SEQUOYAH NUCLEAR PLANT (SQN) - SUPPLEMENTAL RESPONSE TO REQUEST FOR
ADDITIONAL INFORMATION - TECHNICAL SPECIFICATION (TS) CHANGE
REQUEST 96-01 ON CONVERSION TO FRAMATOME COGEMA FUEL (TAC
NOS. M95144 AND M95145)

REVISED RESPONSES TO NRC QUESTIONS 1, 7, 15, AND 20

FIGURE 5.9-2. RELAP5/2 SBLOCA LOCA MODEL
Sequoyah Noding for Primary Loops with Model 51 SGs

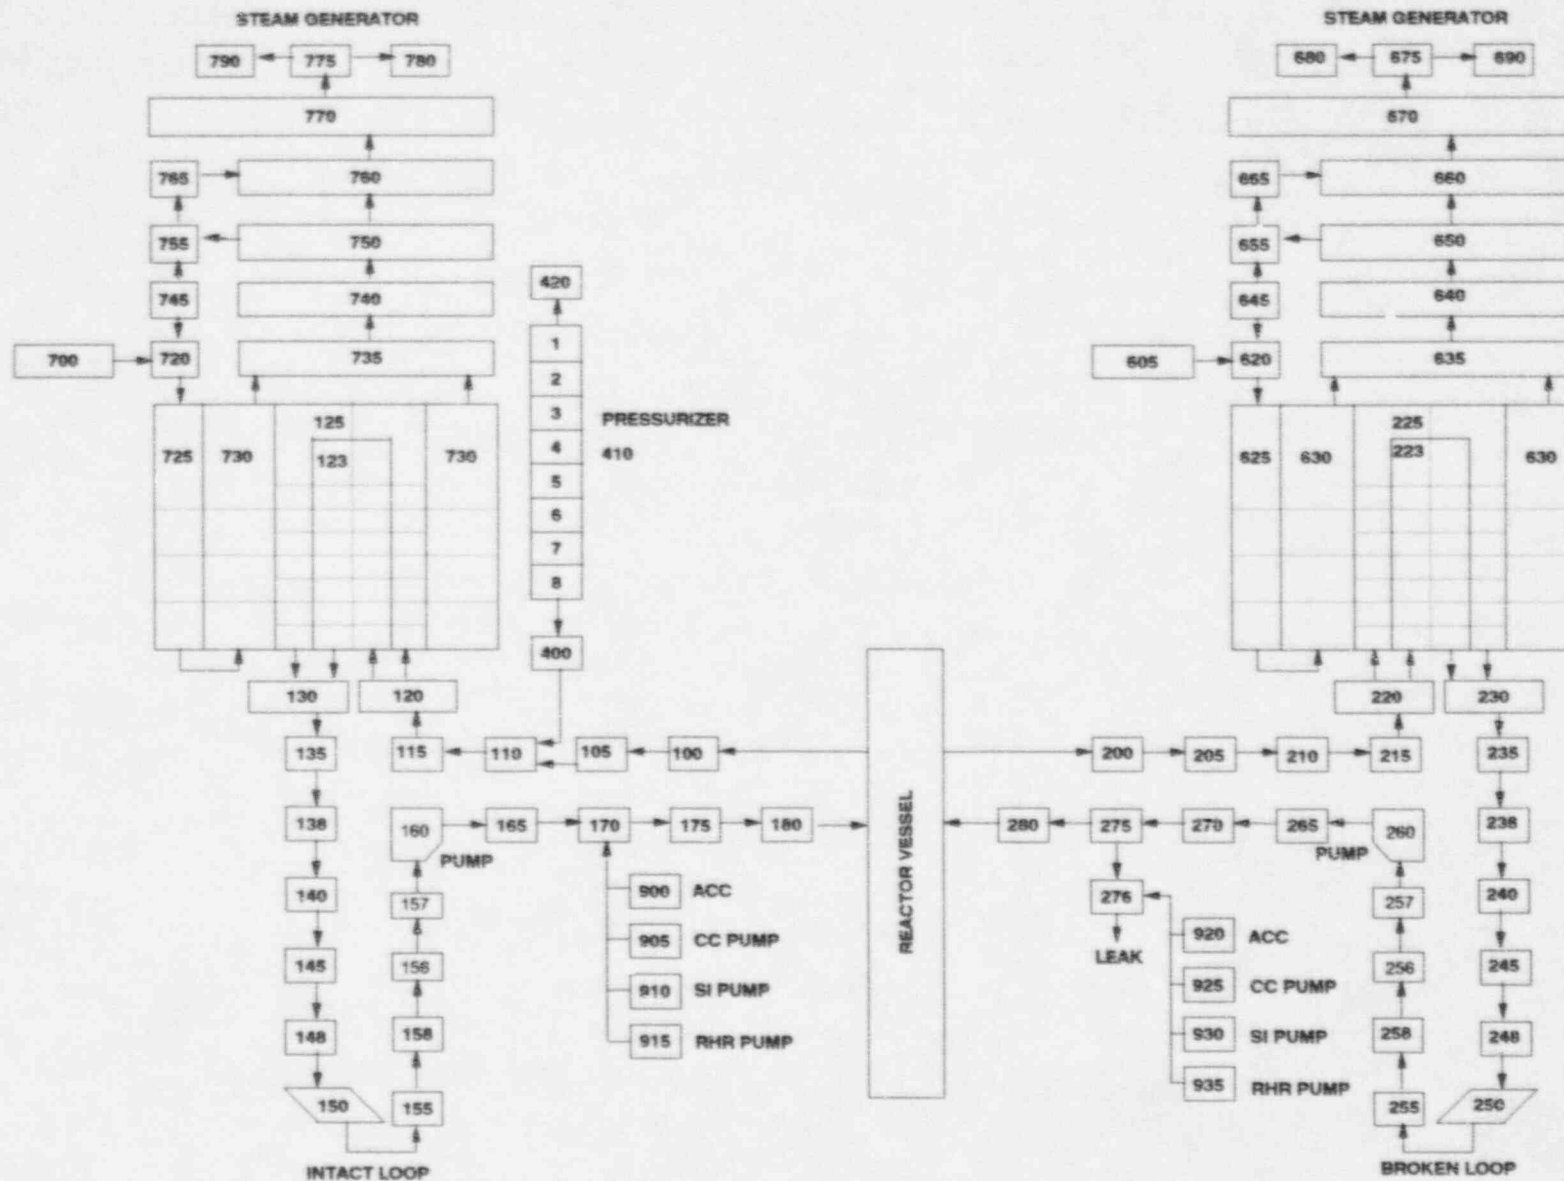
The following supplies supplemental information for the response to Question 1.

The small break LOCA nodding diagram submitted with the response to Question 1 was incorrect in its depiction of the break and the ECCS injection for the broken cold leg. The attached figure replaces that diagram. The artificial break node is shown as node 276 and the ECCS lines for the broken cold leg are shown to be entering node 276.

For the Sequoyah analysis, all of the ECC system flow injected into the broken loop piping is modeled as flowing into node 276 after loop seal clearing has occurred. Prior to loop seal clearing, the CCI flow is modeled as entering the pump discharge piping, node 270; the SI, accumulator,

and RHR are modeled as entering node 276 both before and after loop seal clearing.

Node 276 is modeled as a nonequilibrium control volume. The break flow path, labeled LEAK on the diagram, is modeled as homogeneous. The containment volume area is set equal to the volume area of the break node to eliminate momentum flux gradients during periods of non-critical flow. The flow area for the path connecting the pump discharge piping to the break node, node 275 to node 276, has an area of one third of the area of the RCS piping. All of these selections are in accordance with the approved FTI small break LOCA evaluation model.

Figure 20-1

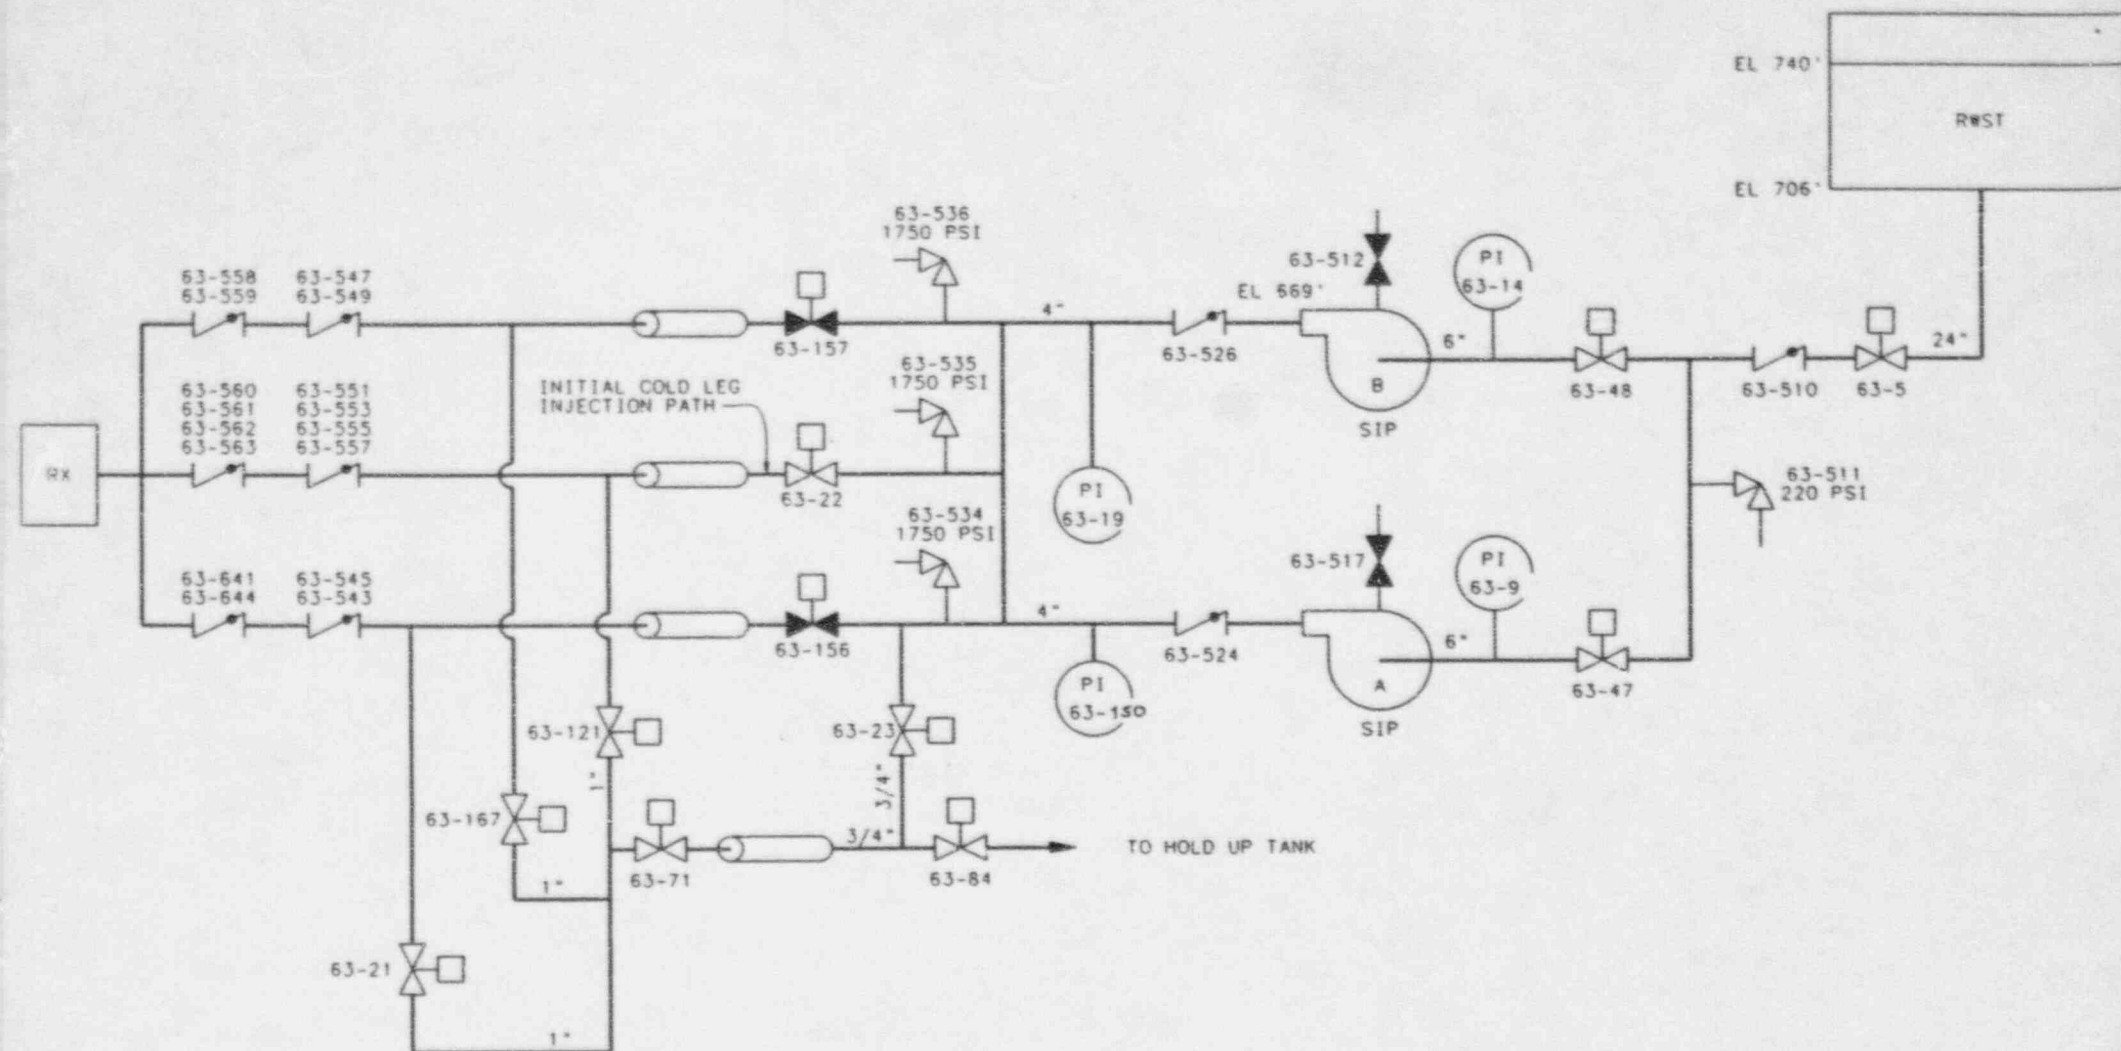
20. For the main steam line break analysis (p. 6-54), the volume of water between the cold leg piping and the first check valve is considered to be at 0 ppm boron concentration. The current Final Safety Analysis Report (FSAR) analysis assumes the volume of water in the piping from the RWST to the cold leg piping (a much bigger volume) is all at 0 ppm. Please describe how you can assure that the water in the piping between the RWST and the first check valve is at least 1950 ppm.

The SI pump casing is vented every 31 days per Technical Specification 4.5.2.b.1. This in turn causes the upstream piping back to the RWST to be vented. Venting occurs until a steady stream of water is noted at the pump casing vent. The pressure source is the head difference between the RWST and the SI pump. The RWST is verified to have at least 2500 ppm boron every 7 days per Technical Specification 3.5.5. The piping downstream of the SI pump is also vented for the hot and cold leg injection paths. The procedure requires that the flowpath through the SI pump, the pump discharge check valve and each test header isolation valve (63-21, 23, 121 and 167) be open for ten minutes, for a total of forty minutes of venting through the piping header. Again, the pressure source is the head difference between the RWST, the SI pump and the discharge piping (see Figure 20-1).

The Technical Specification minimum RWST volume is 375,000 gallons. The volume of water between the SI pumps supply check valve and the RWST tank entrance is approximately 4250 gallons. The approximate volume of water between the SI pump supply check valve and the discharge of one SI pump is 65 gallons. These are the volumes assumed to be at 1950 ppm of boron.

The approximate volume of water between one SI pump discharge and a typical secondary check valve inside containment is 160 gallons. The approximate volume of water between a typical secondary and primary check valve is 60 gallons. The approximate volume between a primary check valve and the hot/cold leg piping is 20 gallons. These are the volumes assumed to be at 0 ppm.

The venting procedures previously described for the downstream piping of the SI pump require venting each of the four paths for 10 minutes each. Based on an average flow rate of 10 gallons per minute for each vent path, a minimum of 400 gallons is displaced in the section of piping between the RWST and the secondary check valves inside containment. An additional volume is also displaced in this suction piping due to the venting of each SI pump casing. This displaced water is replaced with RWST inventory with a minimum of 2500 ppm boron every 31 days.
